<b>Docket Number:</b>	01-AFC-19C
<b>Project Title:</b>	SMUD Cosumnes Power Plant - Compliance
<b>TN #:</b>	225963
<b>Document Title:</b>	Steve Uhler Comments Dear Energy Commission Commissioners, Please confirm the capacity of SMUD's Hedge Power Plant
<b>Description:</b>	N/A
<b>Filer:</b>	System
<b>Organization:</b>	Steve Uhler
<b>Submitter Role:</b>	Public
<b>Submission Date:</b>	11/27/2018 8:50:19 AM
<b>Docketed Date:</b>	11/27/2018

**Dear Energy Commission Commissioners, Please confirm the capacity of SMUD's Hedge Power Plant**

[SMUD's Hedge Photo Voltaic Power Plant CEC RPS ID 60687](#)

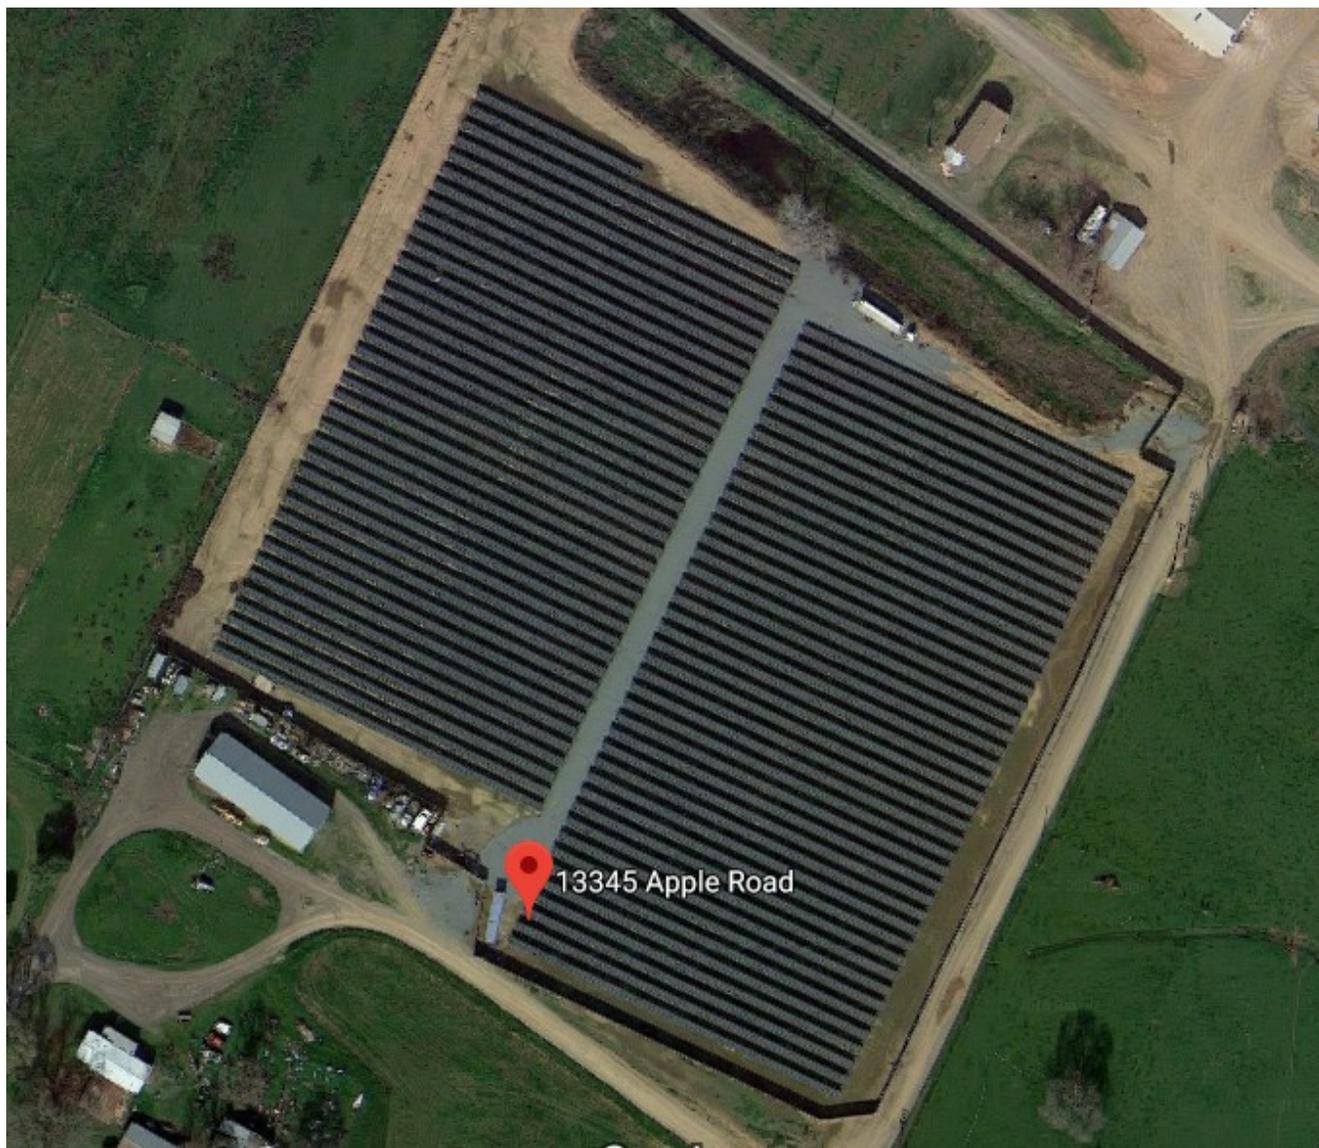
SMUD claims Hedge Photo Voltaic Power Plant is 1.5 MW, please compare this photo of Hedge with photo of a 1 MW photo voltaic power plant.

Why does SMUD claim Hedge Power Plant capacity is 1.5 MW?

Please note width of roadways is about the same in each photo, the scale in each photo is about the same.

Based on a comparison of photos, Hedge power plant does not appear to have the capacity of 1.5 MW.

# PV Issues For SMUD

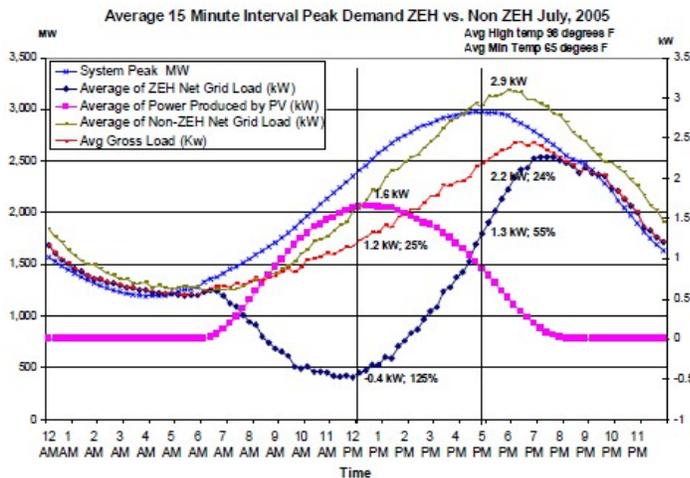
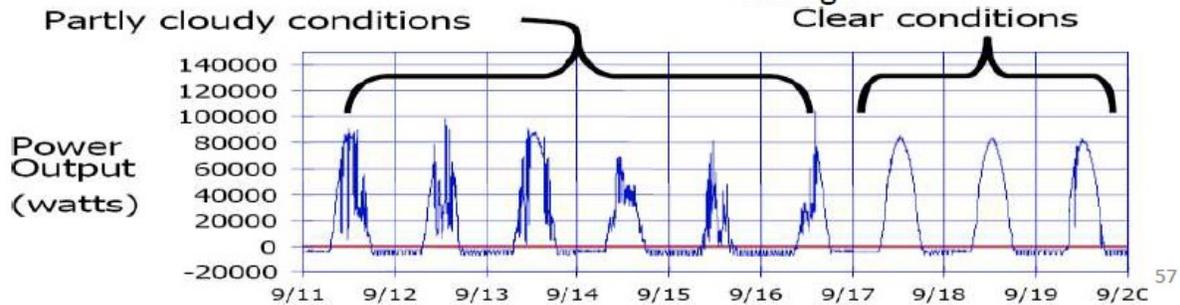
Why are there no charts like these in the modeling report?

[How were these conditions modeled?](#)
